Shearon Harris Nuclear Power Plant, Unit 1
Docket No. 50-400 / Renewed Facility Operating License No. NPF-63

Subject: REQUEST FOR LICENSE AMENDMENT
MEASUREMENT UNCERTAINTY RECAPTURE POWER UPRATE
COMMENTS REGARDING AMENDMENT 139

REQUEST FOR LICENSE AMENDMENT
MEASUREMENT UNCERTAINTY RECAPTURE POWER UPRATE
RETYPE TECHNICAL SPECIFICATION PAGE 2-2

FIGURE 2.1-1
REACTOR CORE SAFETY LIMITS – THREE LOOPS IN OPERATION
WITH MEASURED RCS FLOW > [293,540 GPM X (1.0 + C₁)]

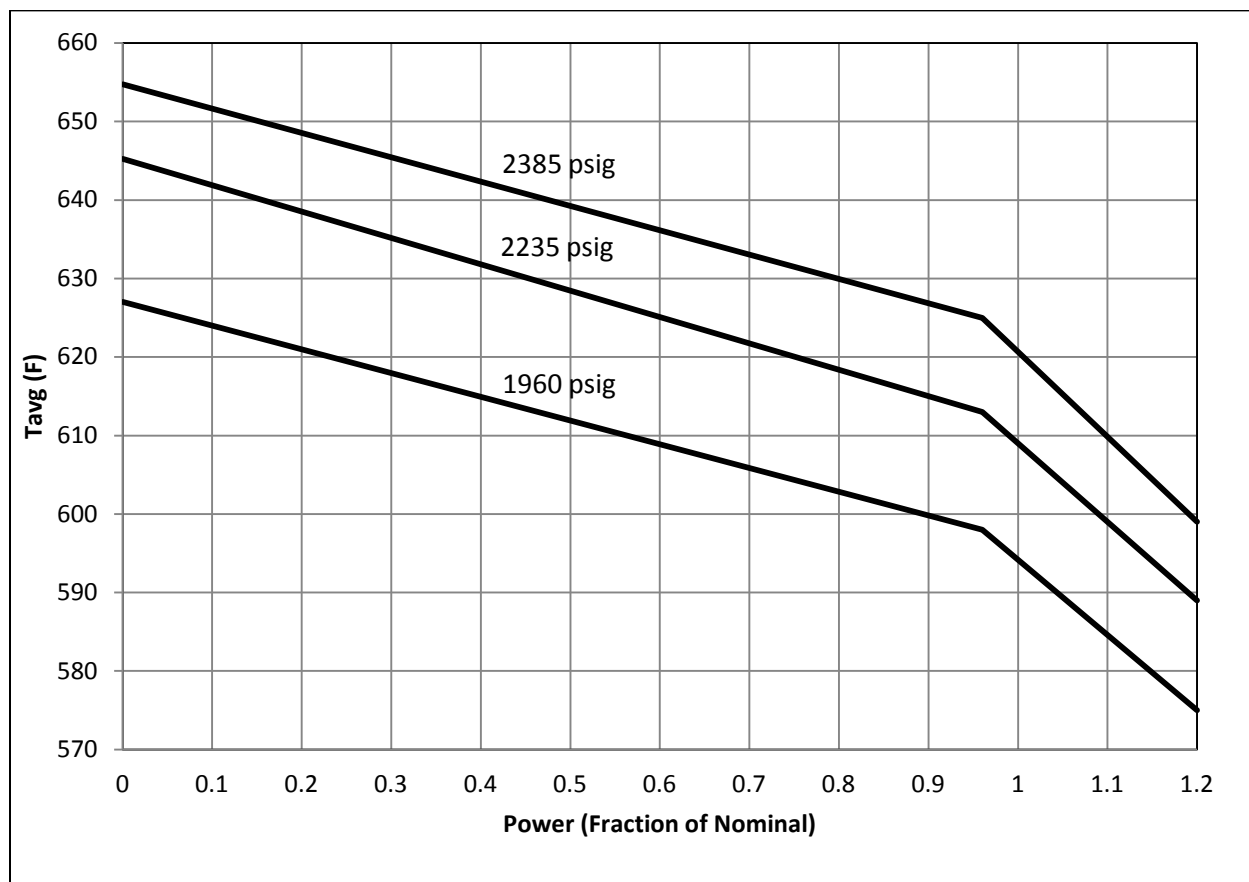
Reference 3, Safety Evaluation, page 67, Table 6 *Technical Specification Figure 2.1-1*, incorrectly correlates the highest pressure data set to a value of 2375 psig. The correct pressure for that data set is 2385 psig.

TS Figure 2.1-1, *Reactor Core Safety Limits*, contains curves of T_{avg} (RCS average temperature) versus Power at pressures of 2385, 2235, and 1960 psig. The data breakpoints corresponding to the curves were correctly provided in Reference 1, Enclosure 1, on page 4 of 18. A request for additional information (RAI) asked that we provide the current and proposed (post-uprate) breakpoints for the three Reactor Core Safety Limit curves. The RAI response, Reference 2, incorrectly identified the pressure corresponding to the upper curve as 2375 instead of 2385 due to a data transcription error from the calculation to the RAI response. The incorrect information was then carried forward from the RAI response to the Safety Evaluation (page 67, Table 6, *Technical Specification Figure 2.1-1*) resulting in correlating the upper curve of Figure 2.1-1, labeled 2385, to a data set incorrectly labeled 2375 psig. The three Reactor Core Safety Limit curves of Technical Specification Figure 2.1-1, both prior and subsequent to Amendment 139, are correctly labeled 2385 psig, 2235 psig, and 1960 psig.

A second error was discovered on the title of Technical Specification Figure 2.1-1 in Amendment 139. Figure 2.1-1, as issued, is titled *REACTOR CORE SAFETY LIMITS - THREE LOOPS IN OPERATION WITH MEASURED RCS FLOW $\geq [293,540 \text{ GPM} \times (1.0 + C_1)]$* . It should be ">" (greater than) instead of " \geq " (greater than or equal to).

The TS markup in the original LAR was correct, however the ">" sign was inadvertently changed to " \geq " in the retyped pages submitted in the LAR. This was caused by an administrative error when retyping the page to incorporate the changed figure (not intended to change the title). ">" is correctly cited in the discussion of Figure 2.1-1 in the LAR and the SE. Please issue a revised Technical Specification page 2-2, changing " \geq " to ">" in the title of Figure 2.1-1, supported by Reference 1, Enclosure, Attachment 1, *OPERATING LICENSE AND TECHNICAL SPECIFICATION PAGE MARKUPS*. The corrected retyped page is enclosed.

The impact is limited to the one number (2375) in Table 6, and does not affect the discussion of how the curves were developed in our LAR, its supplements, or the discussion in the Safety Evaluation. Please issue a revised page 67 to the Safety Evaluation, replacing 2375 with 2385 in Table 6, *Technical Specification Figure 2.1-1*, supported by the correct information in Reference 1.
